PLAN REVIEW SHEET

Date:	3/20/2013	Staff Contact:	Brian Horton
Petition:	2013-040 James P. Ngo & Yen M. Ngo	Telephone:	704-353-0018
		Email:	bhorton@charlottenc.gov
		Attachments:	Concrete Pad Specs

**WAITING PAD ONLY
WITH PLANTING STRIP
STANDARD**

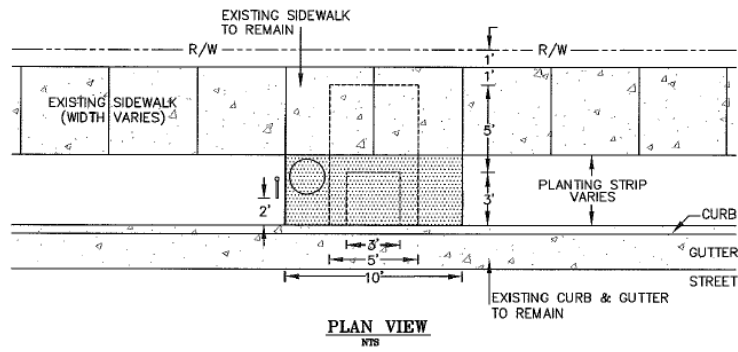
We request that the Petitioner provide a waiting pad for bus service along Sugar Creek Road. The pad may be located 50 feet beyond the proposed Type II driveway, so that a stopped bus will not block the driveway.

If back-of-curb sidewalk is retained, use the CATS pad standard detail 60.01C. If the new sidewalk includes planting strip, use the standard detail 60.01B. Below are images of each standard.
